## Memorandum

Subject: Bassett Creek 2018 Flood Control Project Inspection

**Date:** December 12, 2018 **Project:** 23/27-0051.42 2018 4065

Photographs of Bassett Creek Flood Control Project Features

**Golden Valley Country Club (Golden Valley)**

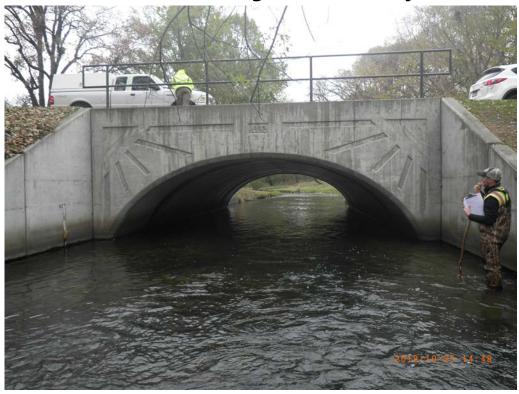
- a. The channel and riprap armoring from Pennsylvania Avenue to the box culvert appeared to be in satisfactory condition.
- b. The box culvert, joints, and railings appeared to be in satisfactory condition.
- c. The overflow weir (earth berm) appeared to be in satisfactory condition and has been maintained by the Golden Valley Country Club staff as manicured fairway turf.

None

**Regent Avenue Crossing (Golden Valley)**

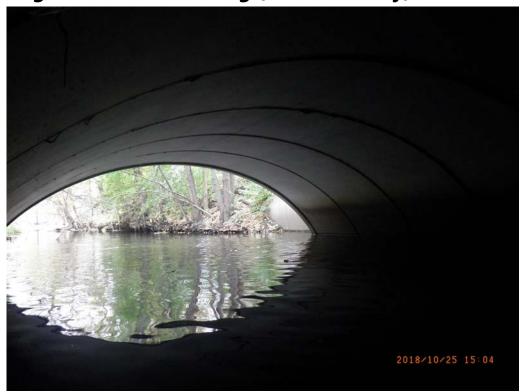
- a. The concrete Bebo culvert appeared to be in satisfactory condition.
- b. The channel bottom was very soft and mucky and the water level was below the staff gauge.

- c. Spalled concrete was observed at the middle joint of the upstream north (left) wing wall. This in consistent with previous inspections and has been noted since 2002.

- d. A crack was observed at the upstream, north (left) wing wall. The crack was near the top of the wing wall and travels at a 45 degree angle down to the headwall. This in consistent with previous inspections and has been noted since 2002.

- e. Multiple cracks were observed at the upstream south (right) wing wall. This consistent with previous inspections and has been noted since 2008.
- f. Spalled concrete was observed around the storm sewer pipe entering the culvert on the north (left) side.

- g. A crack was observed at the downstream south (right) wing wall. The crack was near the top of the wing wall and travels at a 45 degree angle down to the headwall. This is consistent with previous inspections and has been noted since 2002.

- h. Flows appeared to have scoured the north (left) side of the creek bottom and deposited sediment on the south (right) side of the creek bottom.

• Repair spalled concrete at storm sewer connection on north (left) side of culvert.

- Monitor spalled concrete at the upstream north (left) wing wall.
- Monitor crack at the upstream north (left) wing wall.
- Monitor cracks at the upstream south (right) wing wall.
- Monitor crack at the downstream south (right) wing wall.
- Monitor creek bottom for scouring and deposition and, as needed, armor creek bottom along culvert foundation.

Noble Avenue Crossing (Golden Valley), continued

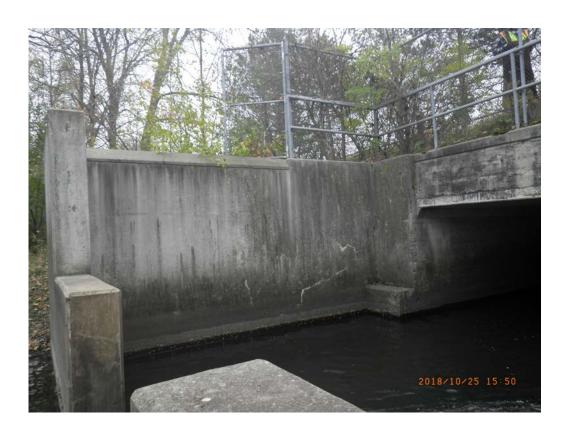
- a. The concrete Bebo culvert appeared to be in satisfactory condition.
- b. Longitudinal hairline cracks were observed throughout the length of the top of the culvert, extending across the entire section (pre-cast section) width. The cracks were either in the center of the structure or approximately 2 feet off-center of the structure. This is consistent with previous inspections and has been noted since 2002.

- c. Spalled concrete and exposed plastic joint material was observed approximately two feet either side of center throughout the length of the top of the culvert. The cement paste covering the plastic joint material has separated and exposed the plastic. This is consistent with previous inspections and has been noted since 2002.

- d. Spalled concrete and exposed rebar was observed around the storm sewer pipe entering the culvert on the north (left) side.
- e. Spalled concrete was observed at the downstream north (left) wing wall. This is consistent with previous inspections and has been noted since 2002.

- f. Multiple cracks were observed at the top of downstream north (left) wing wall. This is consistent with previous inspections and has been noted since 2007.

- g. The downstream south (right) wing wall was slightly leaning toward creek. The top of the lower wall was measured at 5/8" offset from the upper wall in 2002. The offset remained constant at 5/8" until 2005 when the offset was observed at 11/16". The offset was then measured at 1" in 2006 and remained at 1" offset until the 2009 inspection when a 1-1/8" offset was measured. The offset between the top of the lower was and the upper wall has remained constant at 1-1/8" from 2009 to present.

- h. Minor bank erosion and scour was observed on both sides of the downstream wing walls. This is consistent with previous inspections and has been noted since 2002.

- i. Flows appeared to be scouring the north (left) side of the creek bottom.
- j. The paint on the railings is chipping and coming off in a number of locations.

- Repair spalled concrete and exposed rebar at storm sewer connection on north (left) side of culvert.
- Add new coat of paint to railings.
- Monitor cracks and spalled concrete in the culvert and wing walls.
- Monitor bank erosion at downstream wing walls.
- Monitor creek bottom for scouring and, as needed, armor creek bottom along culvert foundation.
